Project: 226052 DFCI-BIDMC New Cancer Hospital - 1 Joslin Place - Construction
1 Joslin Place
Boston, Massachusetts 02215

RFI #0-PB-58: Plumbing Trap Primer Specification Confirmation

6 ELECTRONIC TRAP PRIMING ASSEMBLY DETAIL WITH AIR GAP FITTING

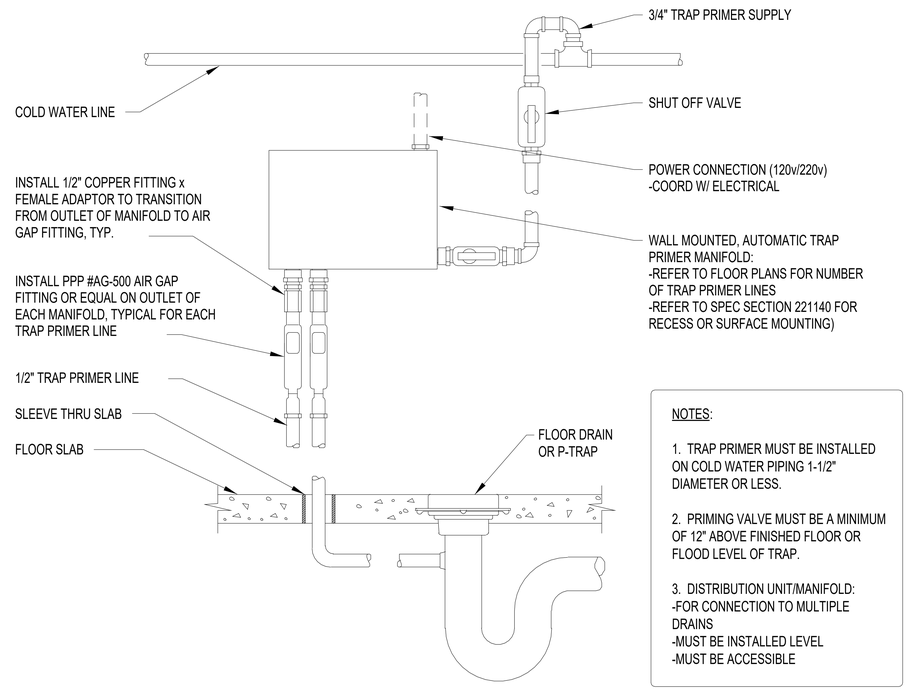
The plumbing specification sections 221140-2.8B & 2.8C (snip shown to the right) specifies that individual fixtures shall be primed by a pressure drop type Trap Primer, while multiple fixtures should be primed by an electronically controlled Trap Primer. The plumbing detail sheets provide a detail for an electronic trap priming assembly with an air gap fitting (snip shown to the right), but they do not provide a detail for a pressure drop type trap primer.

Please confirm that all drains that are subject to evaporation should receive an electronic type trap priming assembly and update the plumbing specifications as needed.

Per Payette 11/21 response: Confirmed. Trap primers will be electronic type trap priming assembly.
